UNITED STATES PATENT AND TRADEMARK OFFICE

10/590,638

Office Action Summary	Application No. 10/590,638	Applicant(s) RAMSAUER, DIETER	
	Examiner KRISTINA R. FULTON	Art Unit 3673

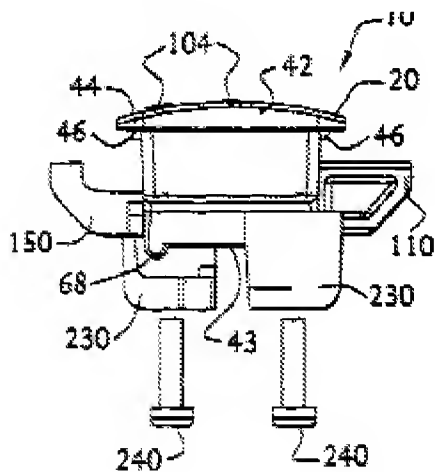
16. Claims 28-29, 31 and 34 are rejected under 35 U.S.C. 102(b) as being anticipated by Vickers (US 6145352).
17. Regarding claims 28, 31 and 34, Vickers teaches a latch having a head part (42) arranged outside a thin wall, a body part (20 below 42) which proceeds from the head part and projects through the opening in the mounted position, holding elements (110 and 150) which project from the body part and are flexible in a direction, a free end of the holding elements being provided with an inclined surface (see figure 3), the body

part and the holding elements being separate parts and the holding elements being slides. Please note "as best understood" for the last limitation of claims 28 and 31 and claim 34, Vickers shows a lock cylinder (200) associated with holding elements (110 and 150).

18. Regarding claim 29 "as best understood", Vickers shows the slides are held against a pressure spring force (198) by a hook arrangement (tabs and slots seen in figures 9 and 10).

19. Regarding claim 31, Vickers teaches the claimed limitations as applied to claim 28 above and further teaches "as best understood" that a slides are held by a spring force (198) and a pin arrangement (tabs and slots of figures 9 and 10). See the Vickers device below.
